W3F1-2004-0073

August 25, 2004

SUBJECT: Supplement to Amendment Request NPF-38-249,
Extended Power Uprate
Waterford Steam Electric Station, Unit 3
Docket No. 50-382
License No. NPF-38

Revised Control Element Assembly Ejection Peak Pressure Analysis Results

Figure 2.13.4.3.2-7
CEA Ejection Core Power vs. Time for Peak RCS Pressure

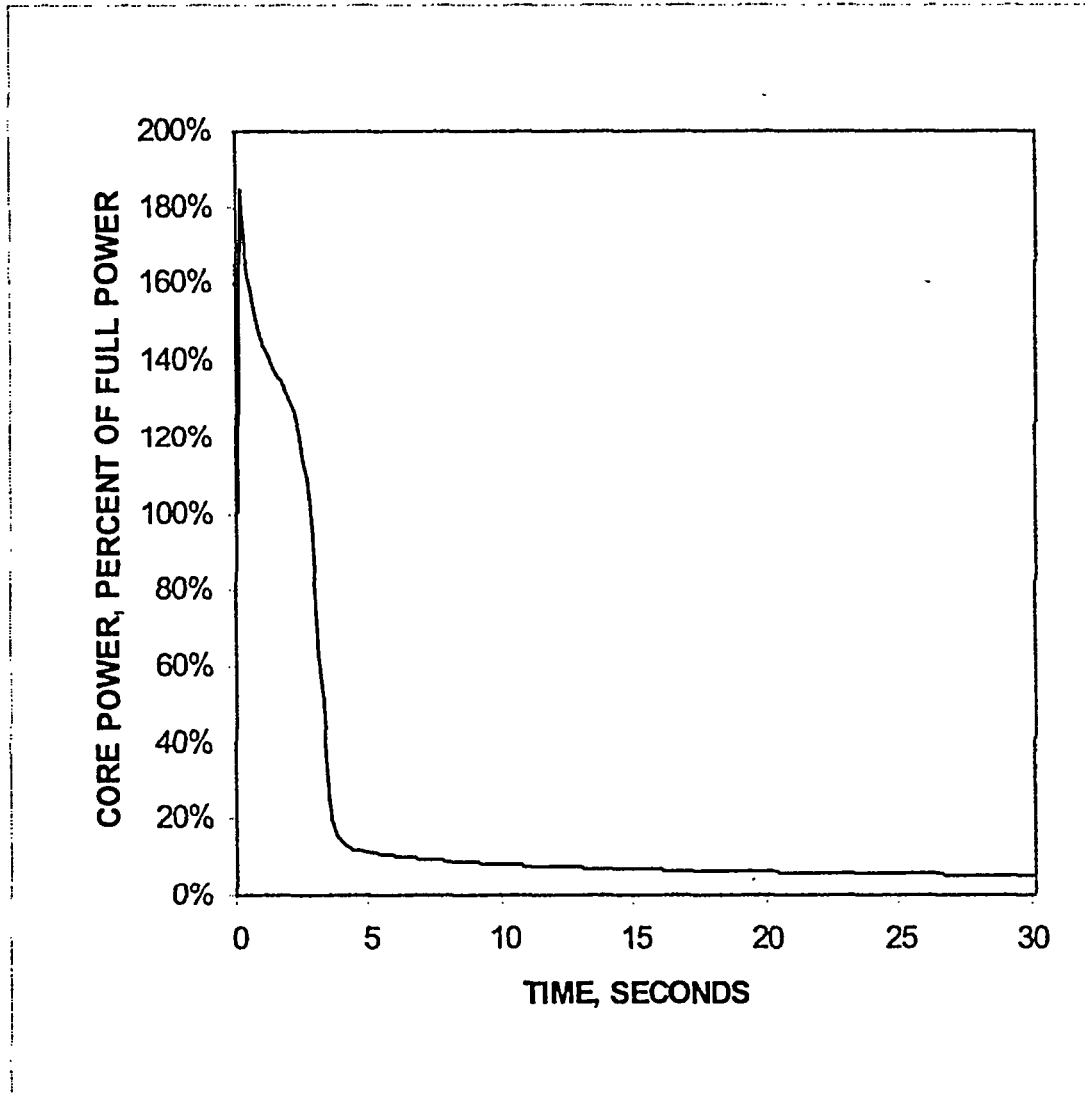
- PUR Tables 2.13.4.3.2-1, 2.13.4.3.2-2 and 2.13.4.3.2-3 are UNCHANGED.
- The information in PUR Table 2.13.4.3.2-4, the RCS Peak Pressure Sequence of Events, is replaced.
- PUR Table 2.13.4.3.2-5 is UNCHANGED.
- PUR Figures 2.13.4.3.2-1 through 2.13.4.3.2-6 are UNCHANGED.
- The core power vs. time response in PUR Figure 2.13.4.3.2-7 is replaced.
- The core heat flux vs. time response in PUR Figure 2.13.4.3.2-8 is replaced.
- The core coolant temperatures vs. time response in PUR Figure 2.13.4.3.2-9 is replaced.
- The RCS pressure vs. time response in PUR Figure 2.13.4.3.2-10 is replaced.
- The SG pressure vs. time response in PUR Figure 2.13.4.3.2-11 is replaced.
- The reactivity components vs. time response in PUR Figure 2.13.4.3.2-12 is replaced.
